Addendum #: Addendum #3
Issue Date: 03/29/2024

Job #: 8-22-01-011 Edgar County Jail
 TBD SPRINGFIELD RD
 PARIS, Illinois 61944

EDGAR COUNTY PUBLIC SAFETY CENTER
 EDGAR COUNTY, ILLINOIS
 12636 950TH ROAD
 PARIS, ILLINOIS 61944
21003.003

F12 PANEL TYPE A 38' = 1'-0" | **F11 PANEL TYPE B** 38' = 1'-0" | **F9 PANEL TYPE D** 38' = 1'-0" | **F8 PANEL TYPE E** 38' = 1'-0" | **F7 PANEL TYPE F** 38' = 1'-0" | **F6 PANEL TYPE G** 38' = 1'-0" | **F4 PANEL TYPE H** 38' = 1'-0"

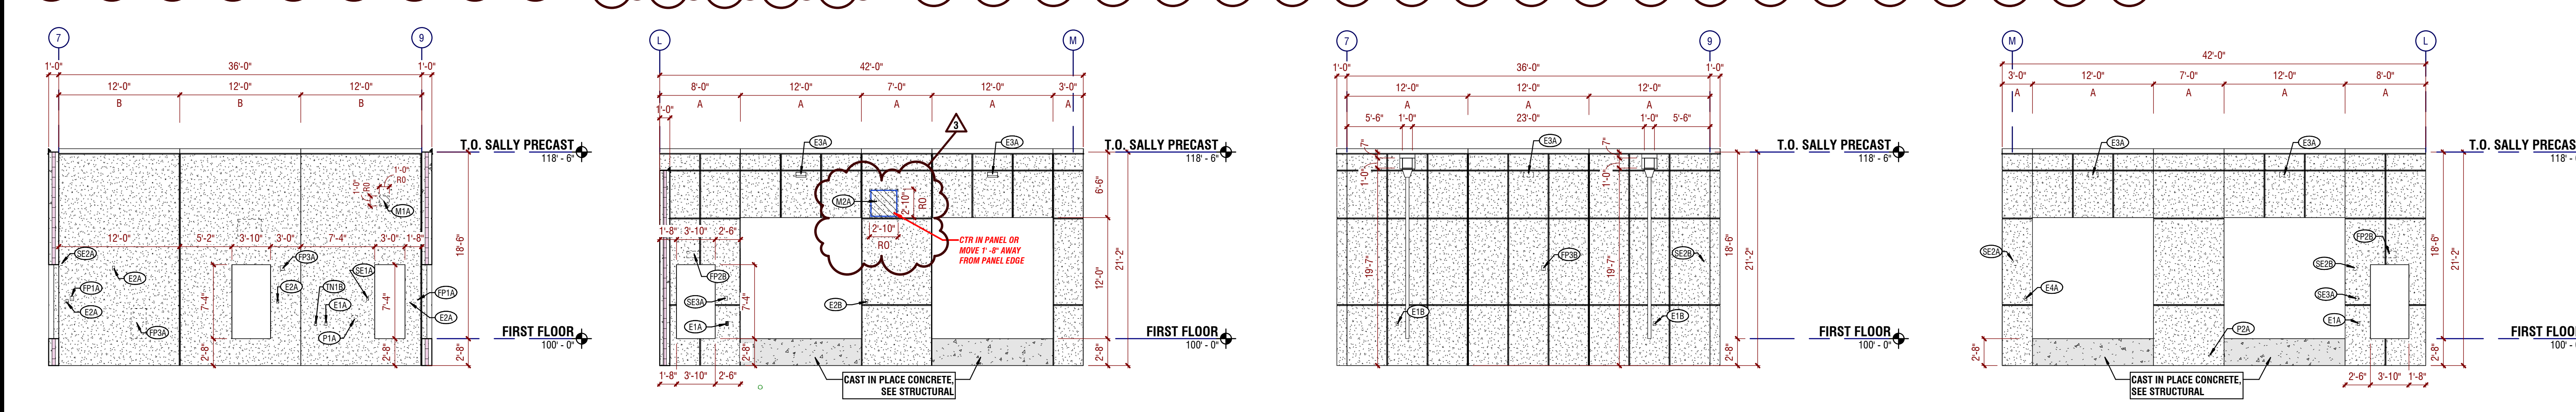
13	F9 and F10/A440 Precast Wall Plane Elevations - Sally Port	REVISE: Detail F10, Panel Type 'C' has been omitted from the project. Detail F9, Panel Type 'D' has been revised.
14	Precast Finish Legend/A440 Precast Wall Plane Elevations - Sally Port	REVISE: Precast Finish Legend F3 Form Liner Finish, REVISE note: "See note 4." in lieu of note 5. REVISE: Precast Finish Legend F4 Form Linter Finish, ADD note: "See Sheet A444 Precast Concrete Panel Patterns for more information." ADD: Sheet A444 Precast Concrete Panel Patterns which shows the information on the F4 form liner finish.
15	A440 Precast Wall Plane Elevations - Sally Port	REVISE: The Precast Finish Legend shall be revised as follows. All precast panels on the exterior of the building shall have the following surface finishes. The exterior side of the precast panel will have a steel form finish with a light sandblast. The interior side will have a smooth steel trowel finish. All precast panels located within the building detention area shall have a steel form finish with a light sandblast on one side and a smooth steel trowel finish on the other side. The surface finishes of the two sides of the interior panels do not need to match.

D12 PRECAST ELEVATION - SHERIFF OFFICE 1/8" = 1'-0" (15/A440) | **D10 PRECAST ELEVATION - SALLYPORT** 1/8" = 1'-0" (16/A132) | **D7 PRECAST ELEVATION - SALLYPORT** 1/8" = 1'-0" (15/A440) | **D4 PRECAST ELEVATION - SALLYPORT** 1/8" = 1'-0" (15/A440)

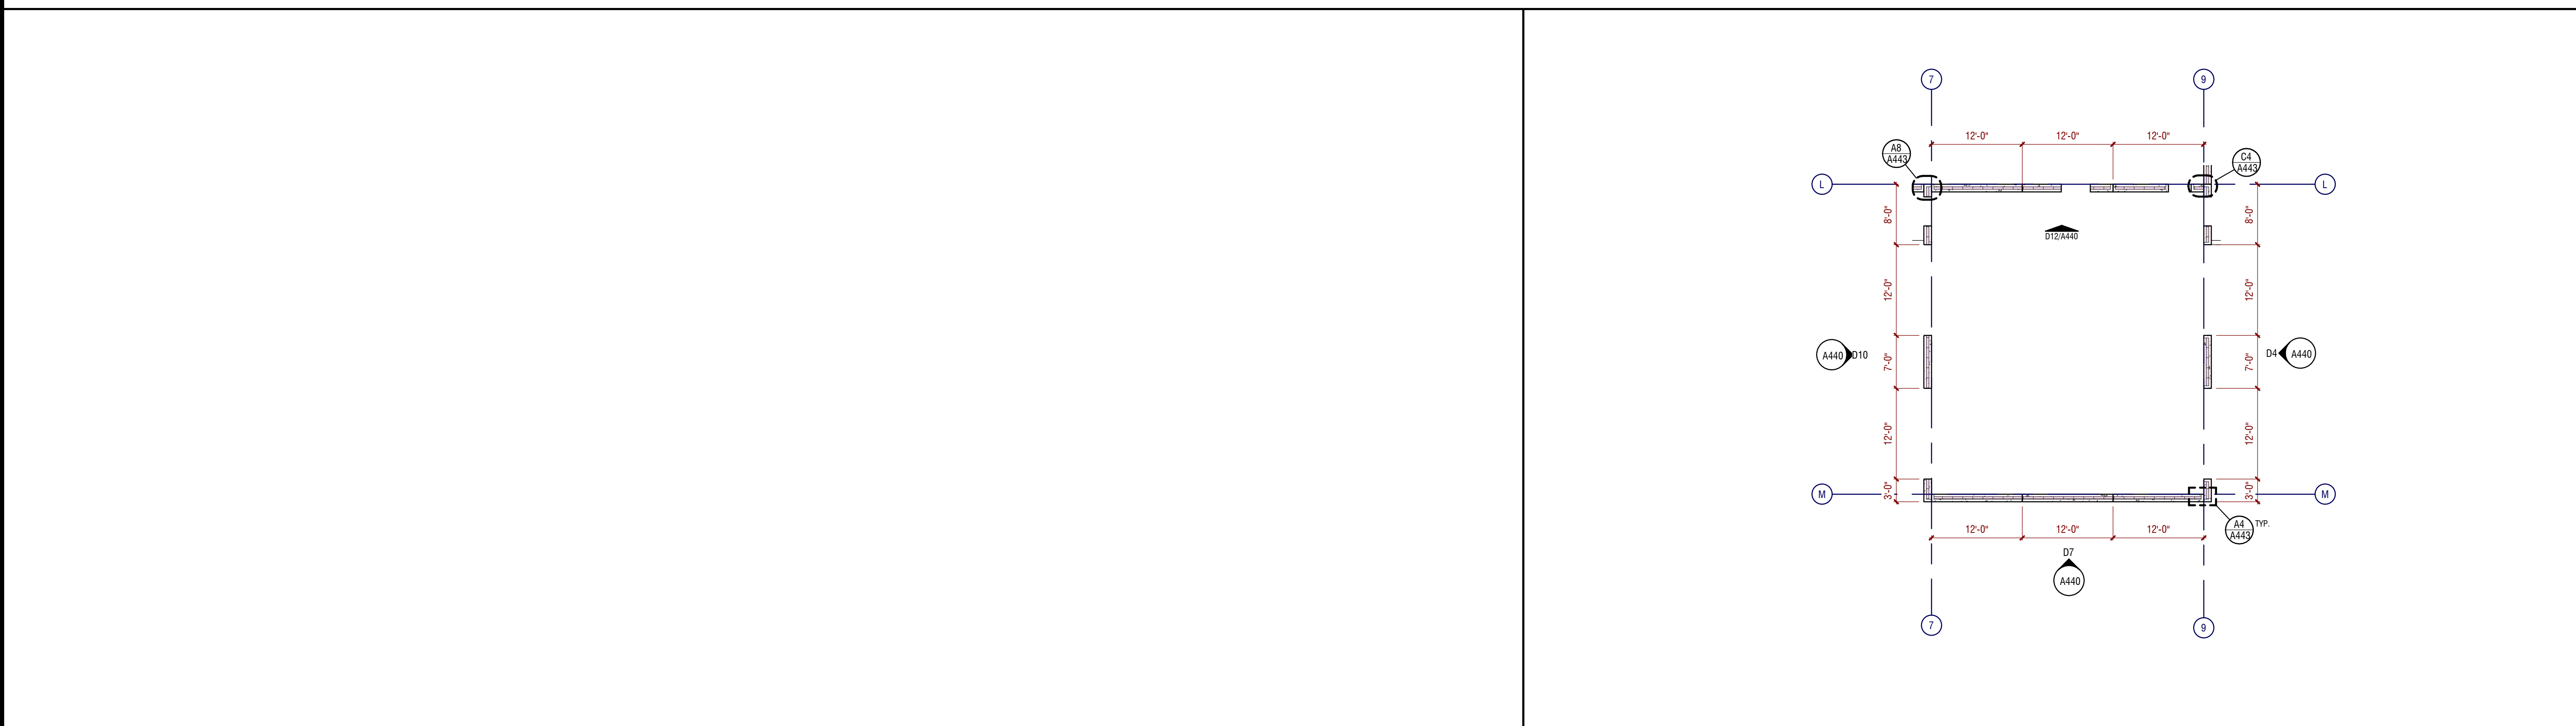
9	D10/A440 Precast Wall Plane Elevations - Sally Port	REVISE: The location of the louver has been adjusted.
10	D12/A440 Precast Wall Plane Elevations - Sally Port	REVISE: The smoke damper originally shown in the doorway has been relocated to an opening within the precast.
11	D12/A440 Precast Wall Plane Elevations - Sally Port	REVISE: The smoke damper originally shown in the doorway has been relocated to an opening within the precast.
12	D12/A440 Precast Wall Plane Elevations - Sally Port	REVISE: The elevation of the ceiling mounted vent for Decon Room #165 has been adjusted. See sheet.

A10 PRECAST ELEVATION - SHERIFF OFFICE 1/8" = 1'-0" (A8/A130)

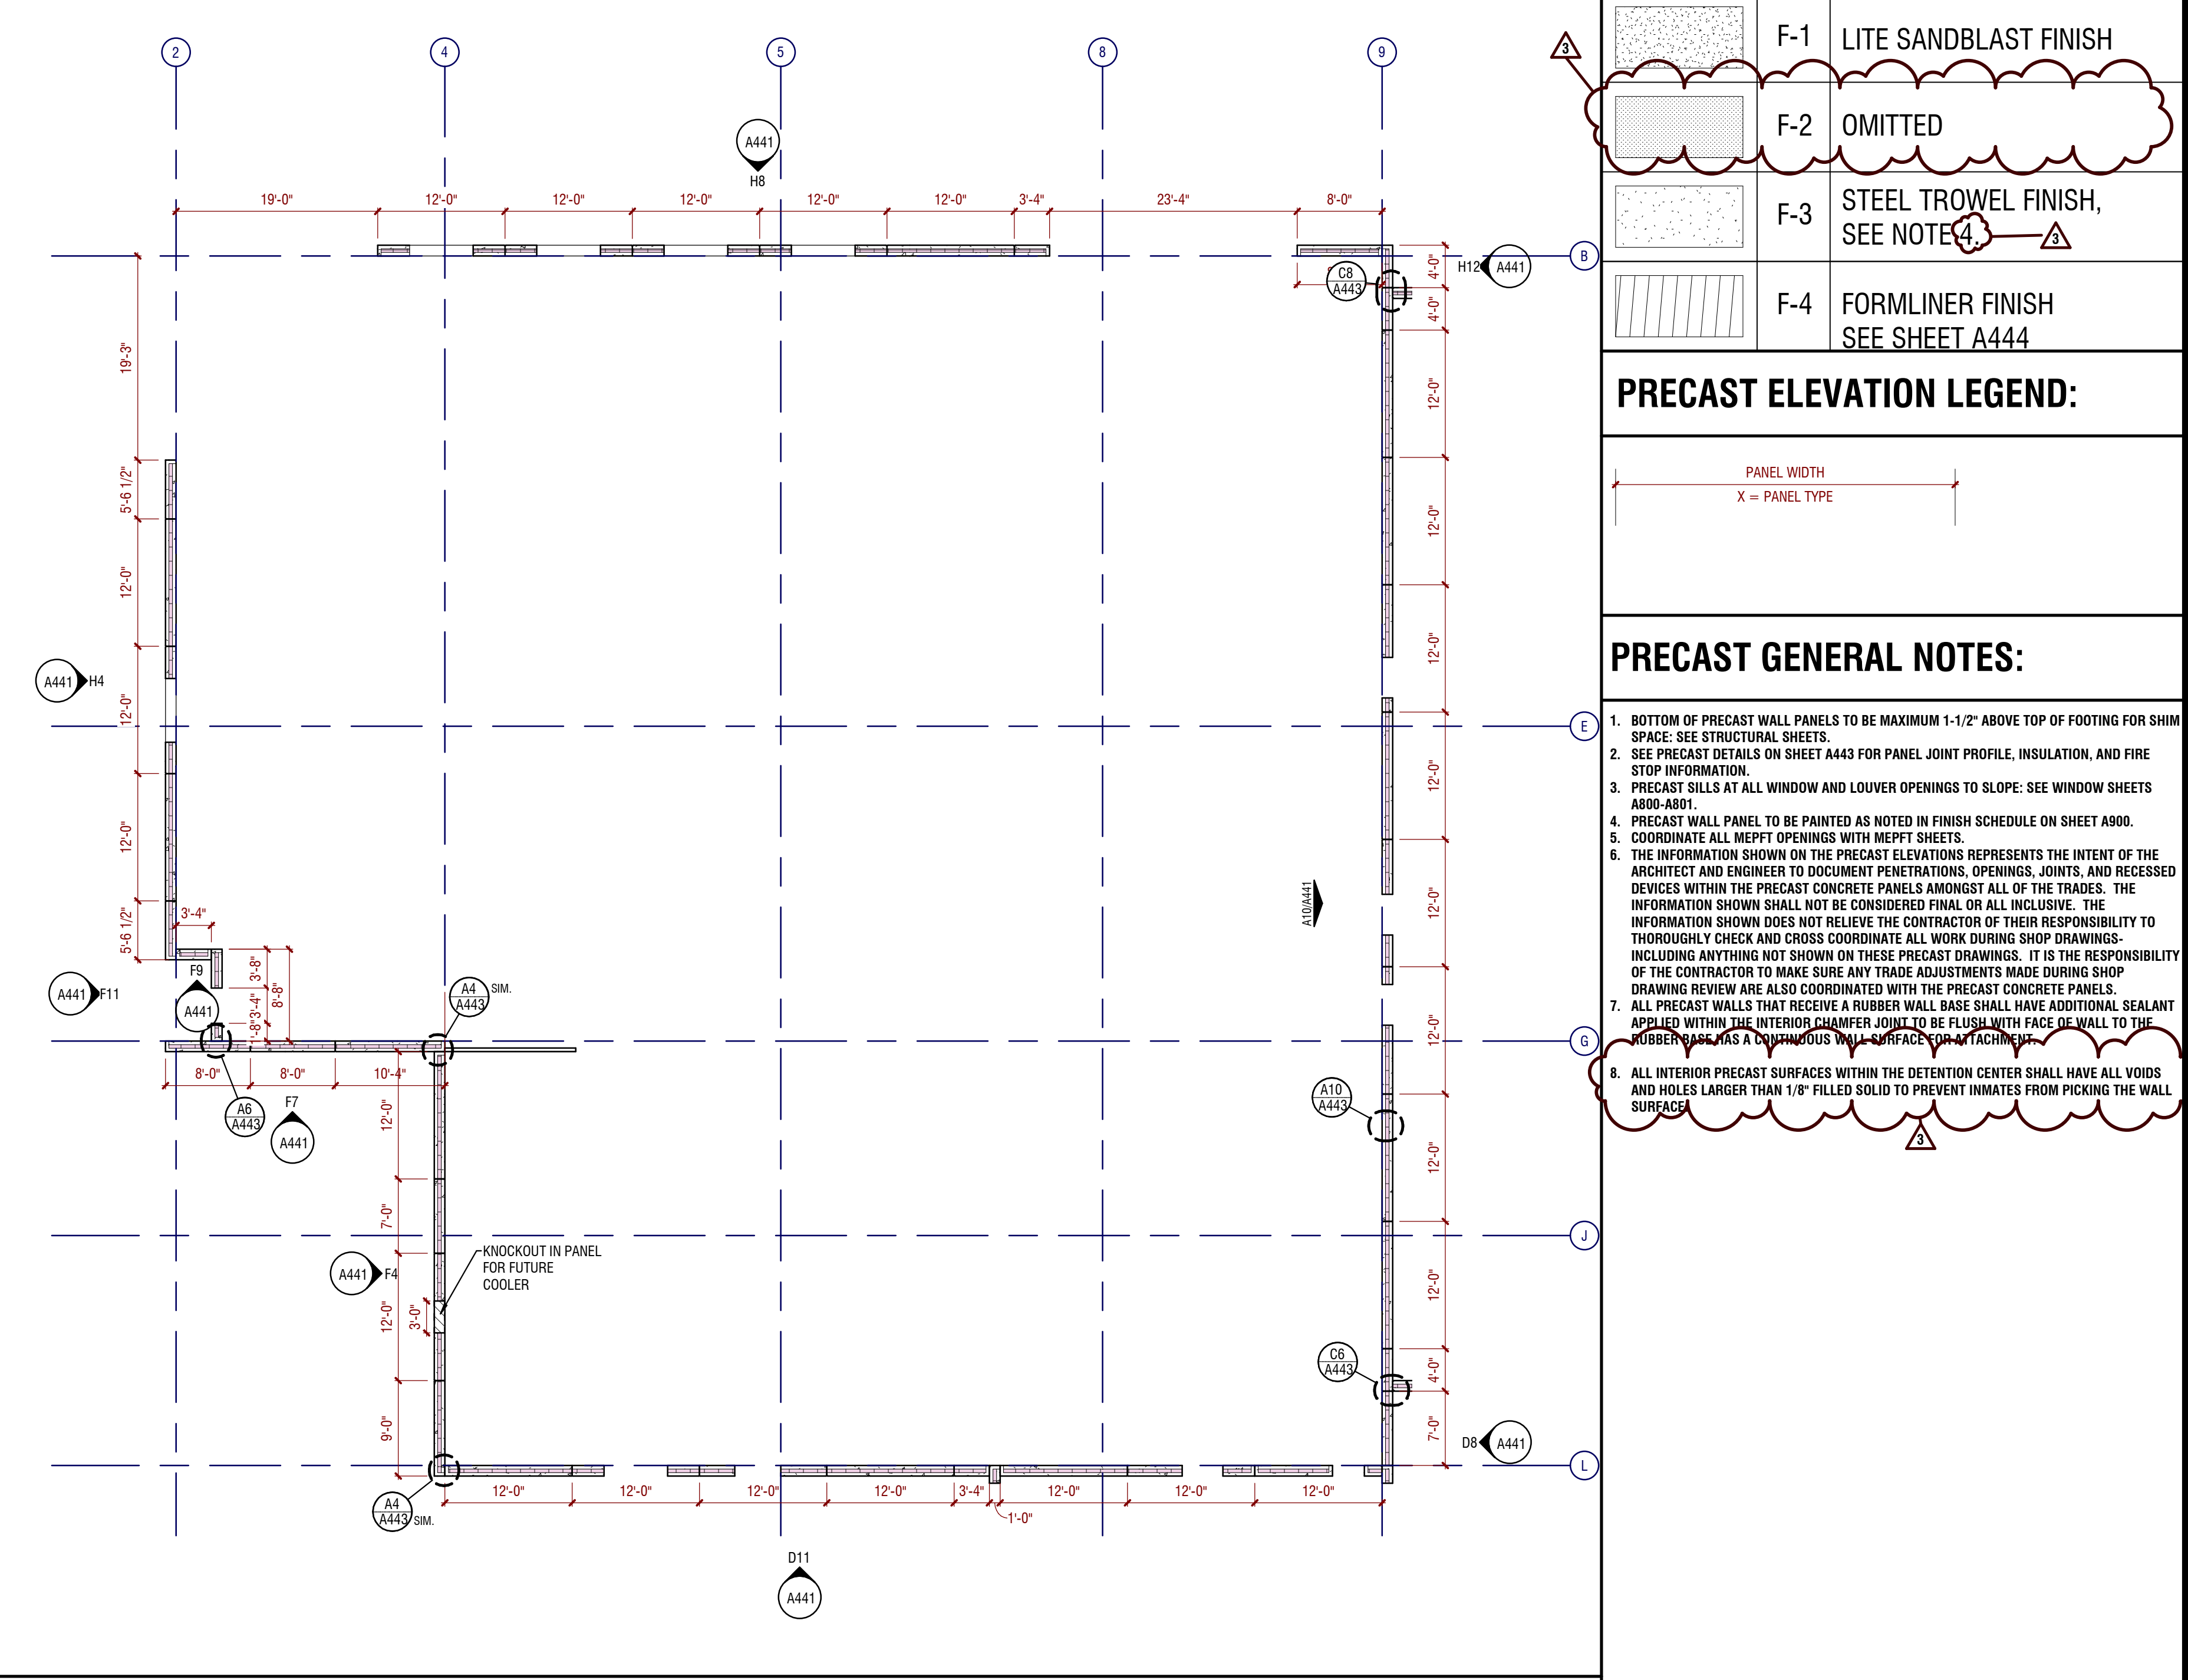
19	A10/A441 Precast Wall Plane Elevations - Sheriffs Office	REVISE: Locations of the mechanical openings in the Precast Panel have been adjusted.
20	F4/A441 Precast Wall Plane Elevations - Sheriffs Office	REVISE: Adjust camera locations on precast concrete panels to avoid the panel joints.
21	E6/A442 Precast Wall Plane Elevations - Detention Center	REVISE: Mechancial openings originally shown on the precast panel joints have been relocated away from the panel joints.
22	E4/A442 Precast Wall Plane Elevations - Detention Center	REVISE: The mechanical opening(s) in the precast panel for ductwork shown notched at the top of the precast panel has been moved lower into precast panel so the top of duct insulation is even with the top of the precast panel.

F5 EXTERIOR MEDALLION SIGN
1 1/2" - 1 1/4" (W/A300)

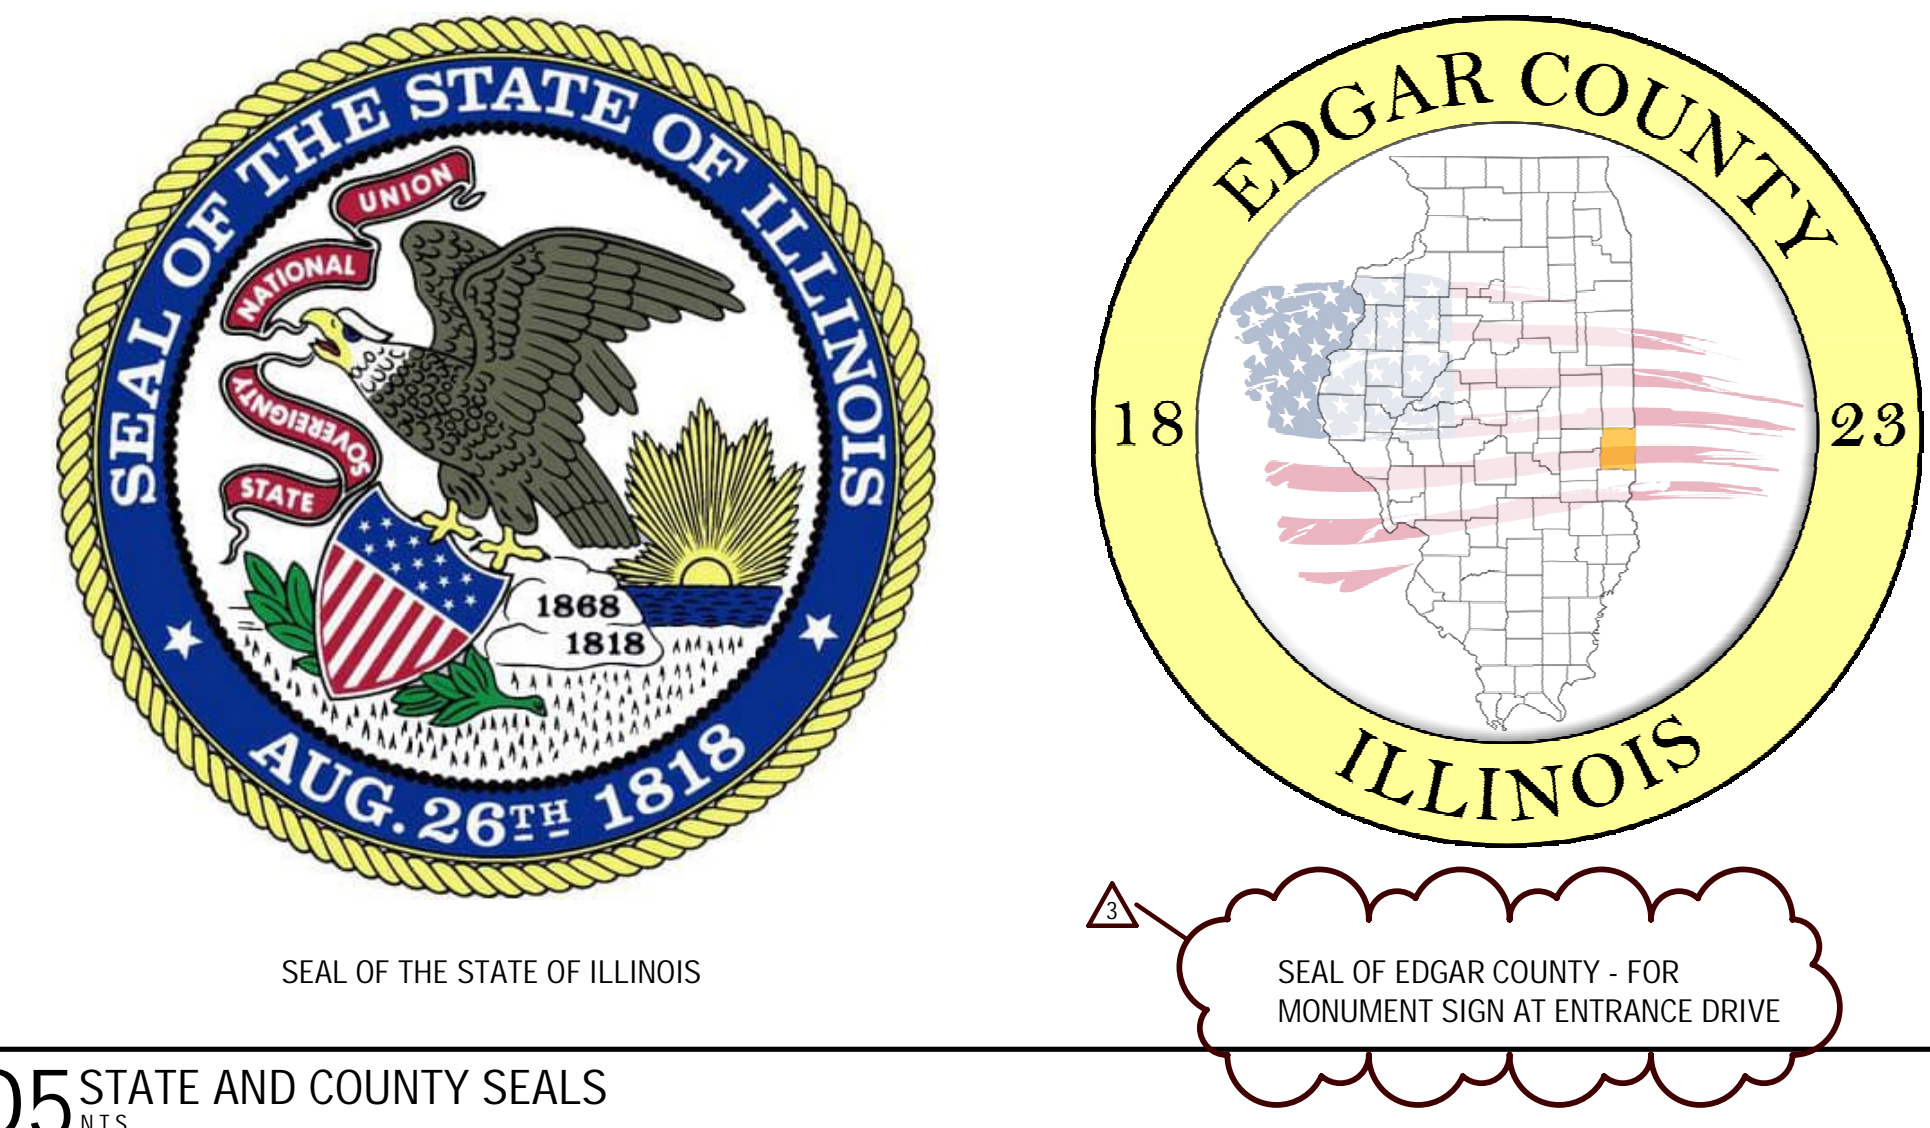
33	F5/A540 Signage Details	CLARIFY: There are no exterior signs made of steel. All exterior signs are made of aluminum. See Sheet A540 for exterior sign information.
34	F5/A540 Signage Details	CLARIFY: The Type E Medallion sign has the following pieces as shown in the detail. Back panel is 48" diameter x 1/4" flat aluminum with additional panel of 3/8" (or deeper as required for Halo Lighting) with an etched OR painted detail for the letters and badge/rope); and a third panel, 10" diameter etched state seal; 2 of these signs required for exterior use.
35	Sign type D, A540 Signage Details	REVISE: Type D lettering is a total of 58 letters, per building elevations on sheet A300. Type D sign/A540 is revised.
36	D4 and F4/A850 Security Glazing Elevations and Details	CLARIFY: The partition designations are on sheet A101. For Partition Types, refer to sheet G130. The exterior precast panels are 12" thick with continuous insulation. The precast panels located entirely within the building have either a solid 8" thickness (Partition Type P8) and 10" thickness with continuous insulation (Partition Type P10). P10 is found around the Exercise Room. Details D4 and F4/A850 have been updated with revised notes.
